HEARINGS EXAMINER MEETING AGENDA
Wednesday, September 23, 2015, 6:00 PM
City Municipal Center, 616 NE 4th Avenue

A. Meadows Subdivision (File #SUB15-01)

Details: The Meadows Subdivision is a 15-lot single-family residential subdivision. The applicant requests preliminary plat approval to subdivide approximately 3.8 acres of residentially zoned land (R-7.5) into 15 single-family residential lots ranging in size from 5,248 square feet to 9,000 square feet. The proposal includes a stormwater detention facility, a wetland and buffer, and a private road that is accessed off of NW Sierra Street.

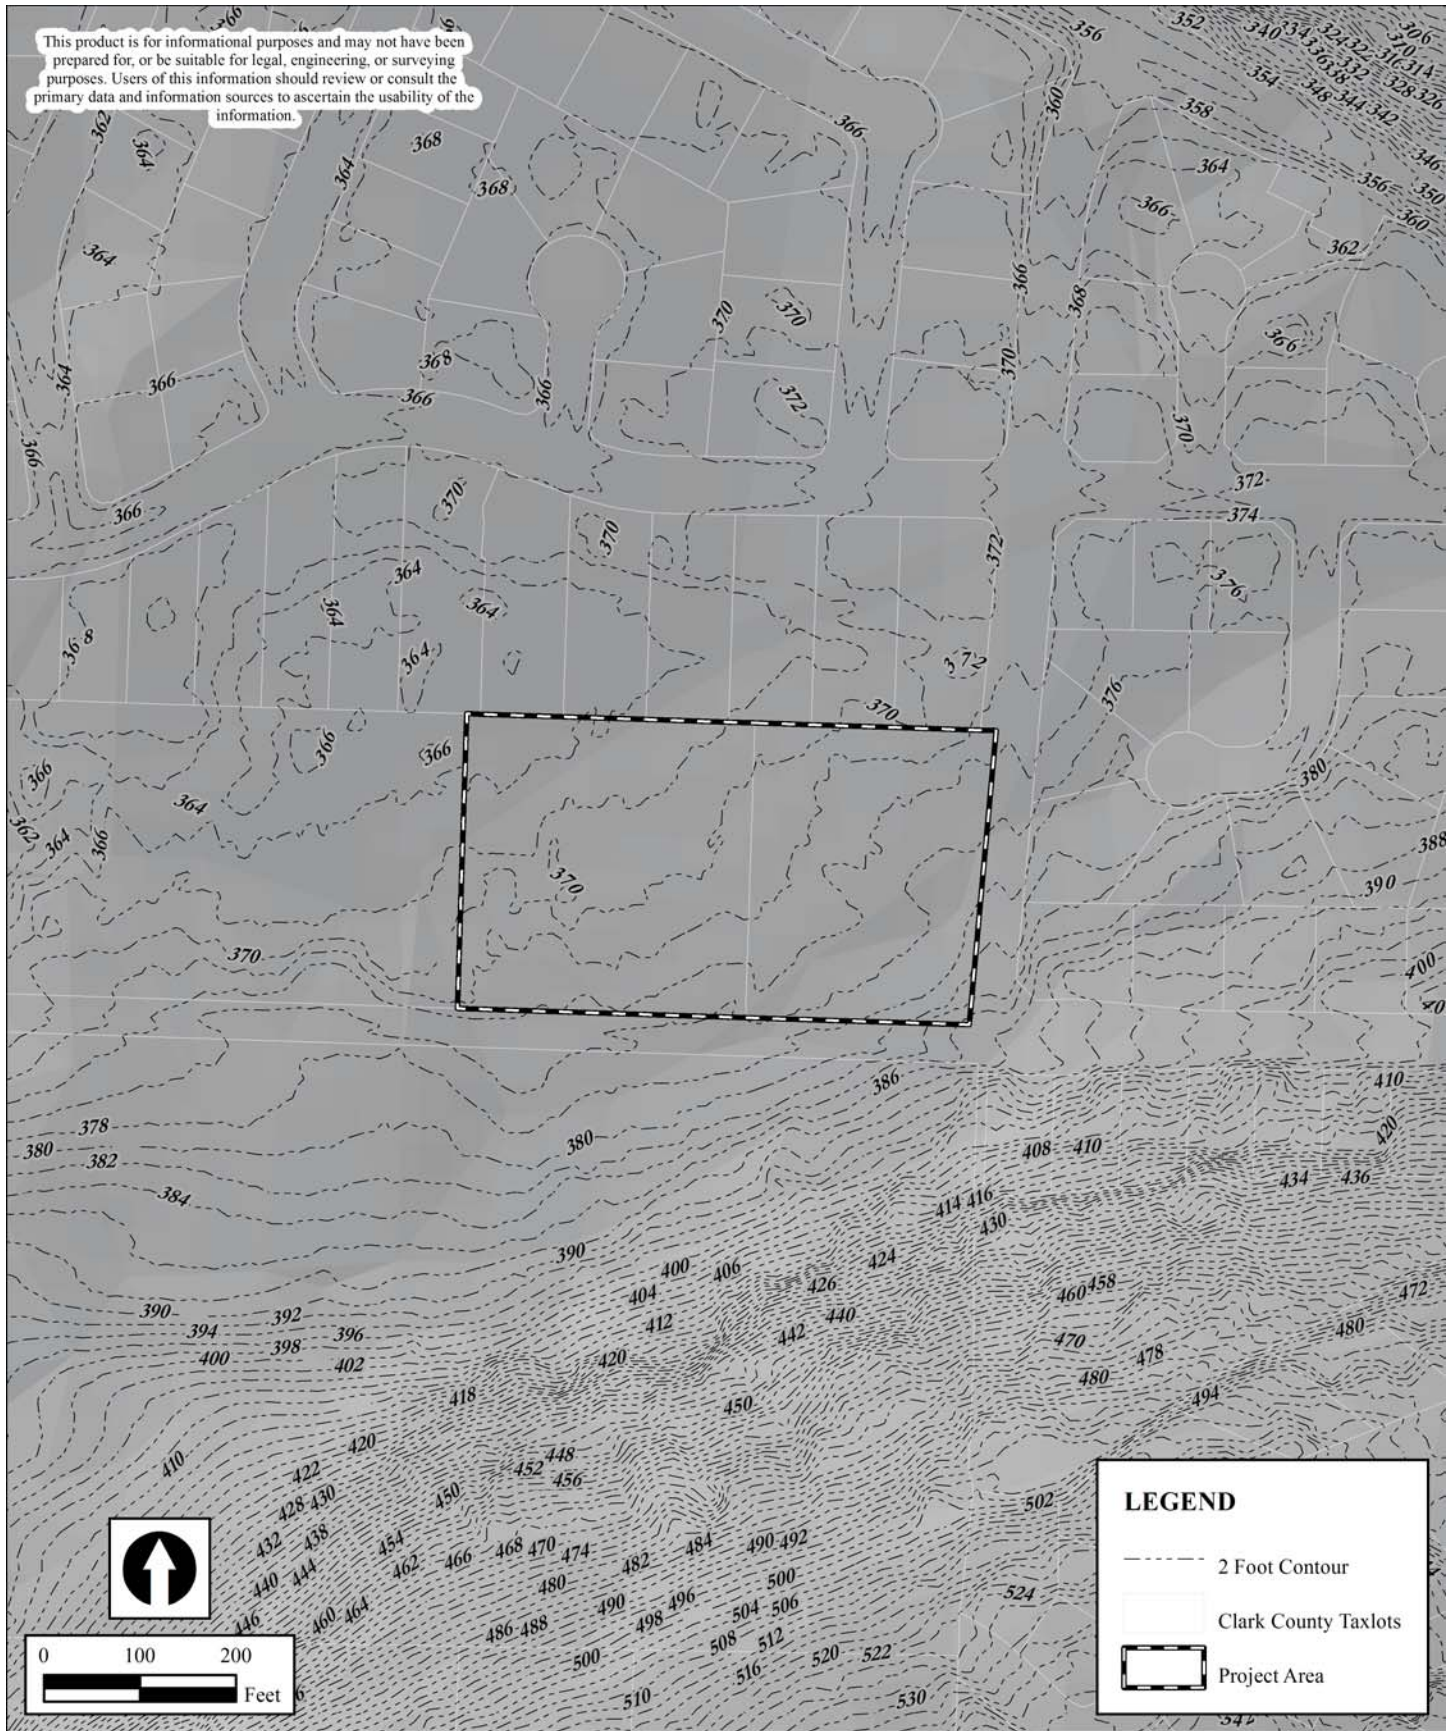
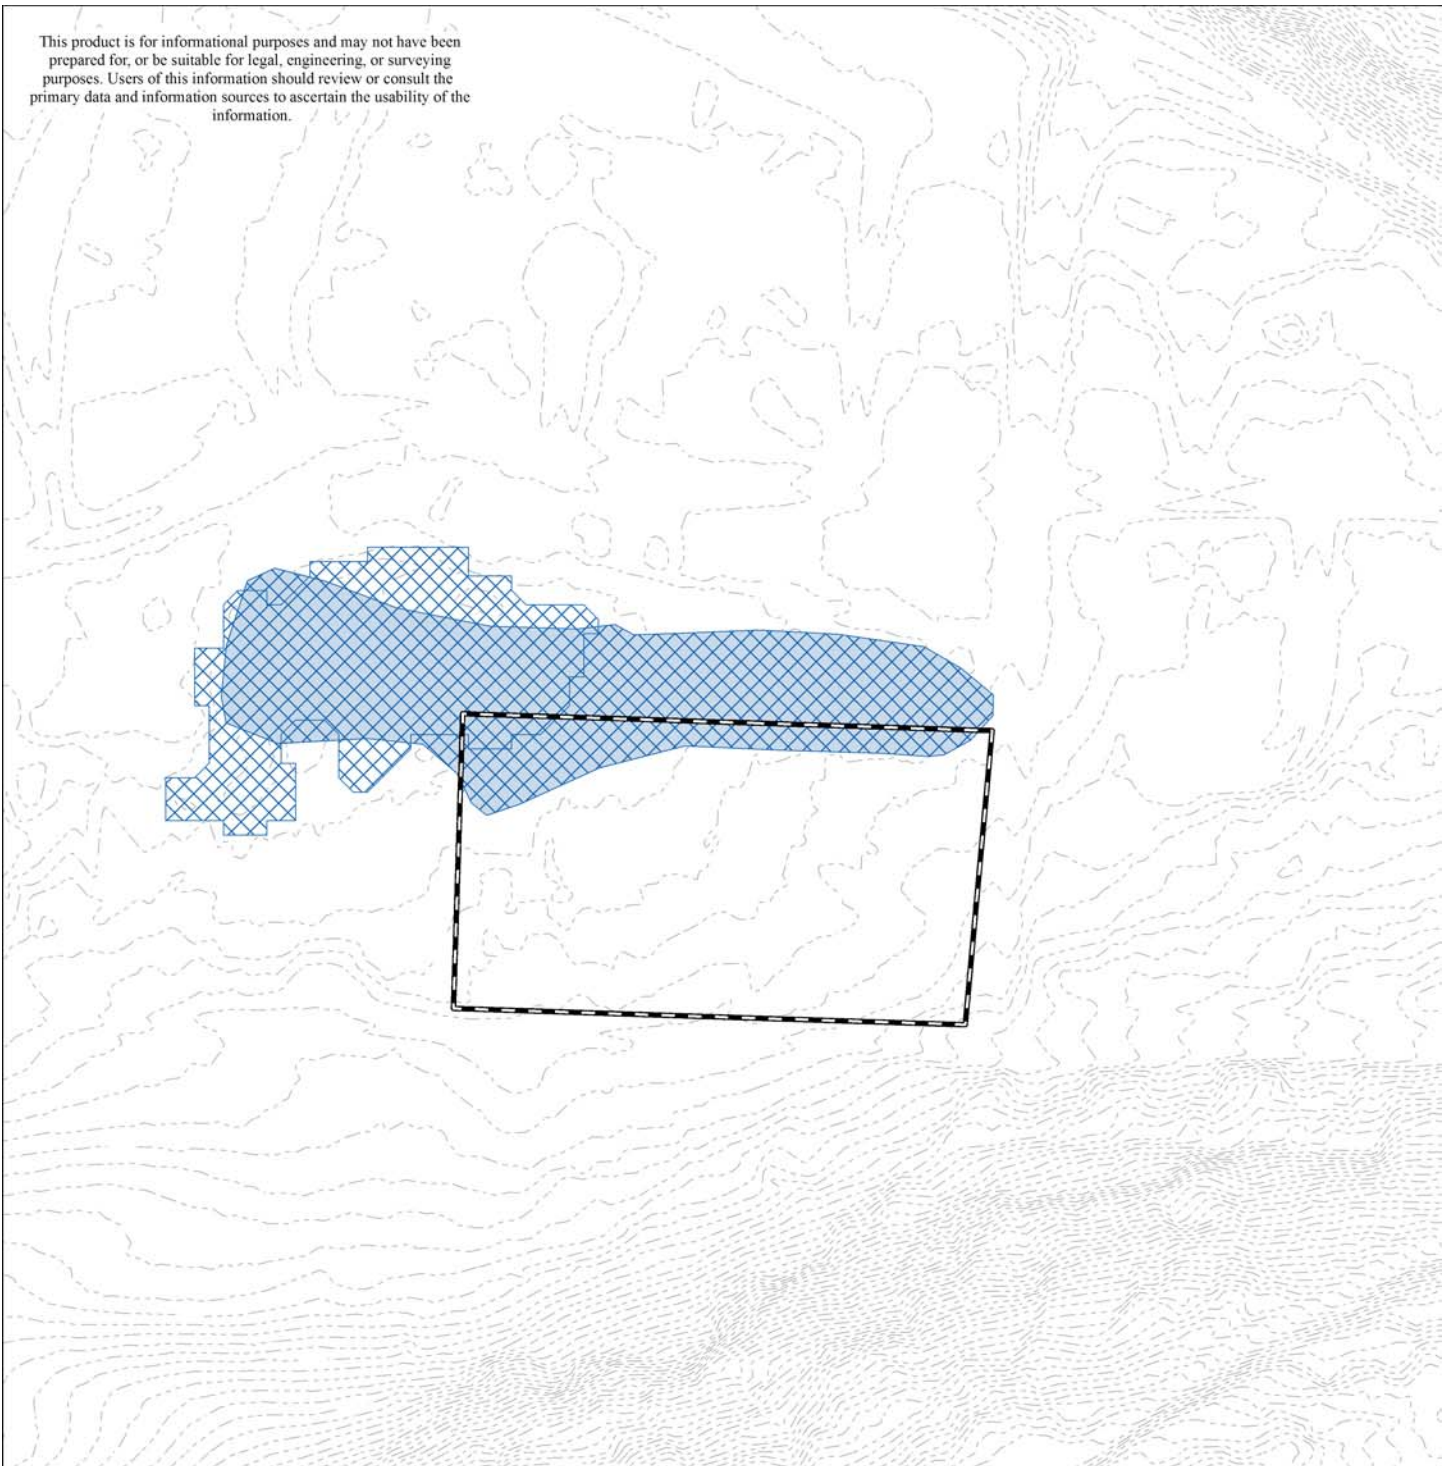
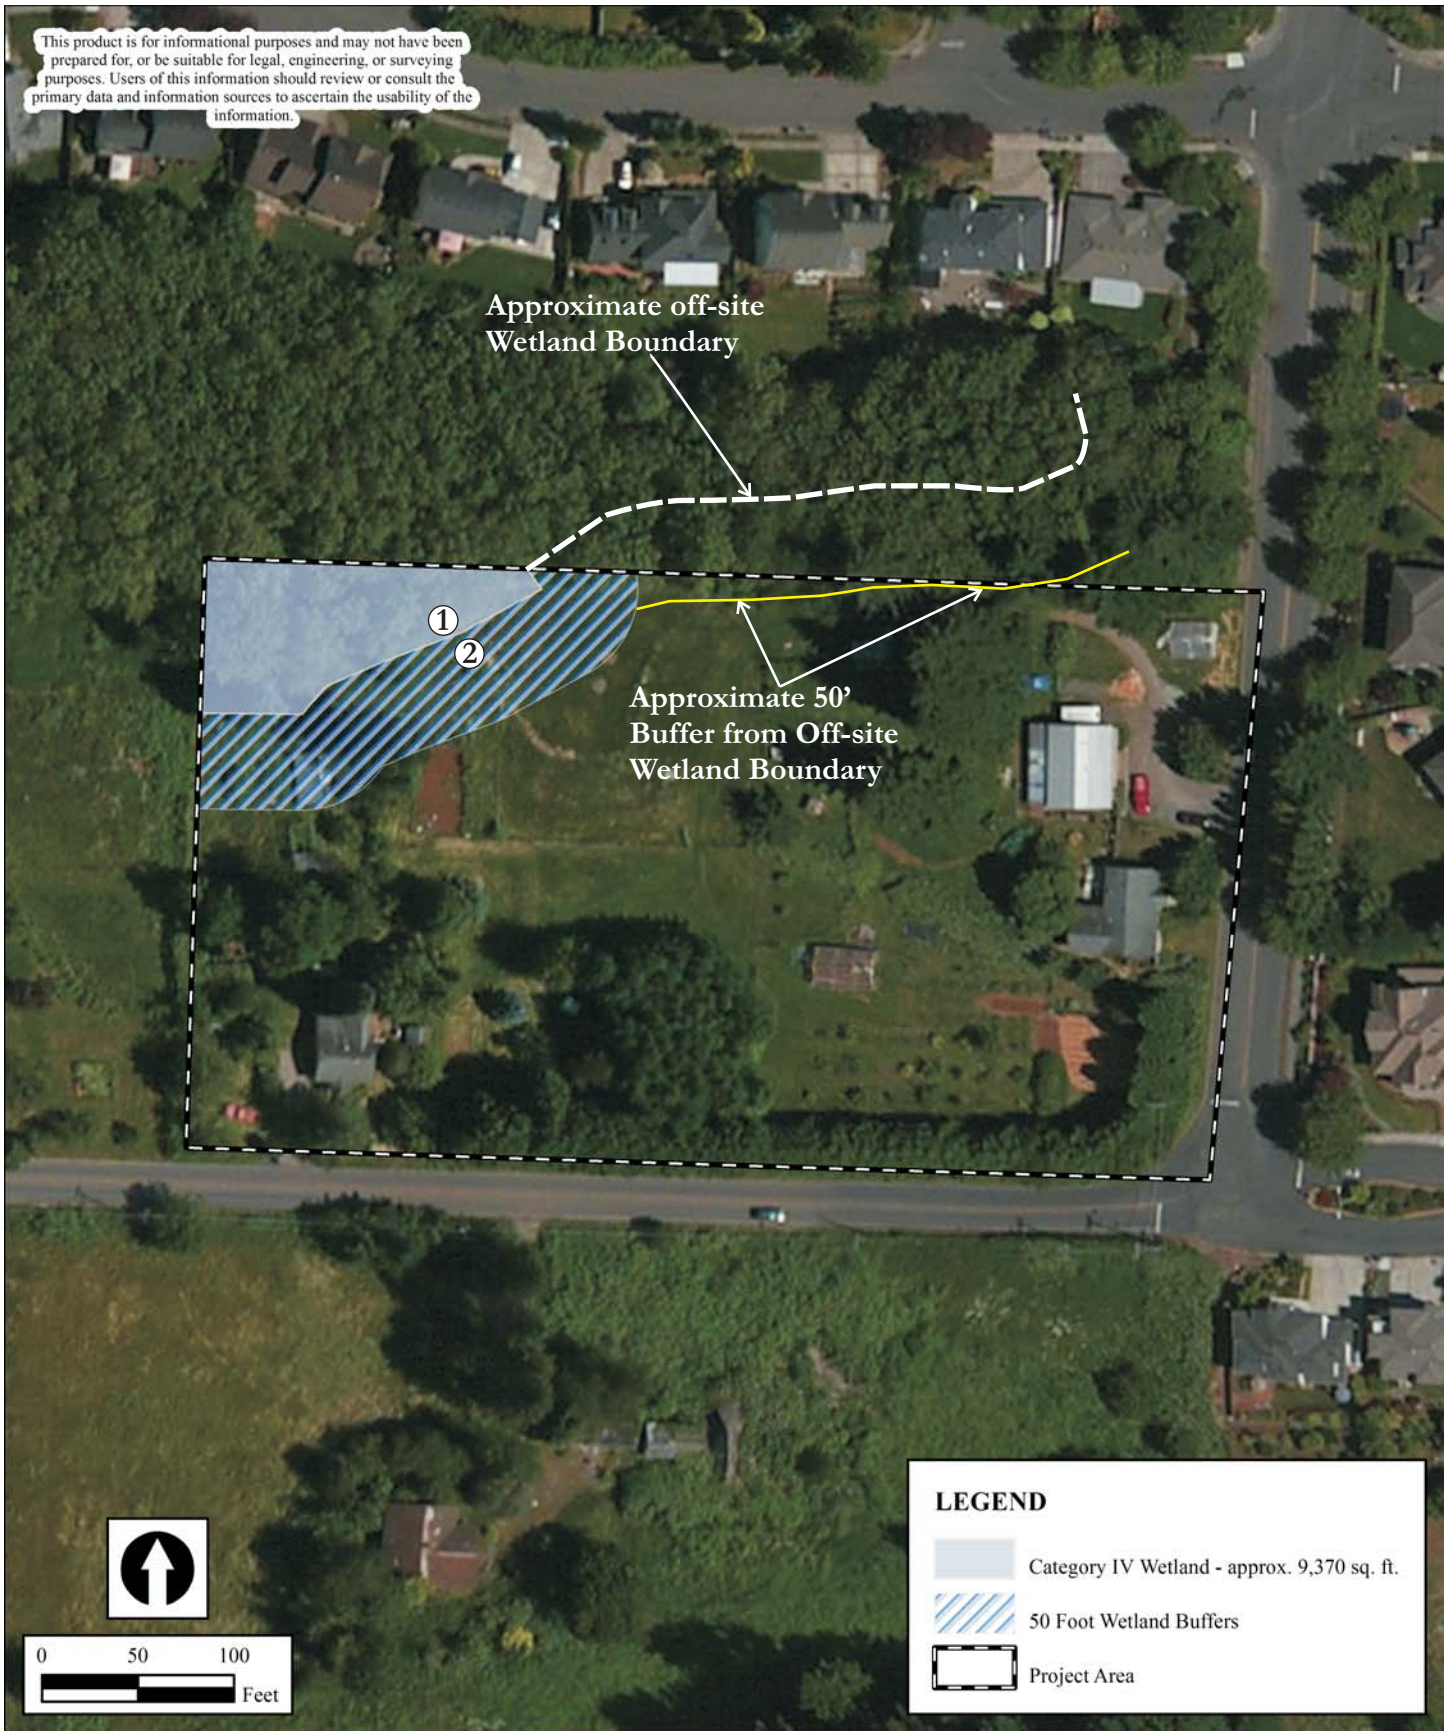
- Figure 5 of the Wetland Delineation and Assessment report outlines the Project Area and approximates the wetland boundary and the buffer boundary. The buffer boundary presented in Figure 5 (which indicates the buffer extending nearly to the northeast corner of Lot 15) conflicts with the buffer boundary presented in the preliminary plat map (which shows the buffer extending only to the northwest corner of Lot 15).

- In Figure 5 of the Wetland Delineation and Assessment report, the approximated wetland boundary and buffer boundary appear to branch off incorrectly from the shaded wetland and buffer areas indicated on the figure. Because the wetland buffer zone is 50 feet from the wetland boundary, the approximated buffer boundary line should exactly mirror the approximated wetland boundary line and it does not.

shown in Figure 5. The report does not state how the offsite boundaries were determined, and it does not indicate that the portion of the wetland located offsite was delineated. The offsite wetland boundary can be accurately approximated without conducting a detailed site visit of the offsite area and delineating the wetland area beyond the Project Area.

- Due to the existing data that indicates the presence of wetland areas across the entirety of the northern area of the Project Area (Figure 3 of the Wetland Delineation and Assessment report, and the approved plat maps for the adjacent properties to the north of the Project Area [see Attachment B]), it would be expected that multiple paired sample plots be taken across the entire northern portion of the Project Area during the delineation. However, only two sample plots were taken in only one corner of the Project Area, as described in the Wetland Delineation and Assessment report.

- The Local Wetland Inventory and/or National Wetland Inventory (Figure 3 of the Wetland Delineation and Assessment report), which shows that the wetland boundary extends into the entirety of the northern portion of the Project Area.
- The approved plat maps for the adjacent properties to the north of the Project Area (Lake Pointe Phase 1), which shows that the wetland boundary extends at least to the northern property boundary of the Project Area; therefore, a the wetland buffer zone would extend at least 50 feet into the northern portion of the Project Area.
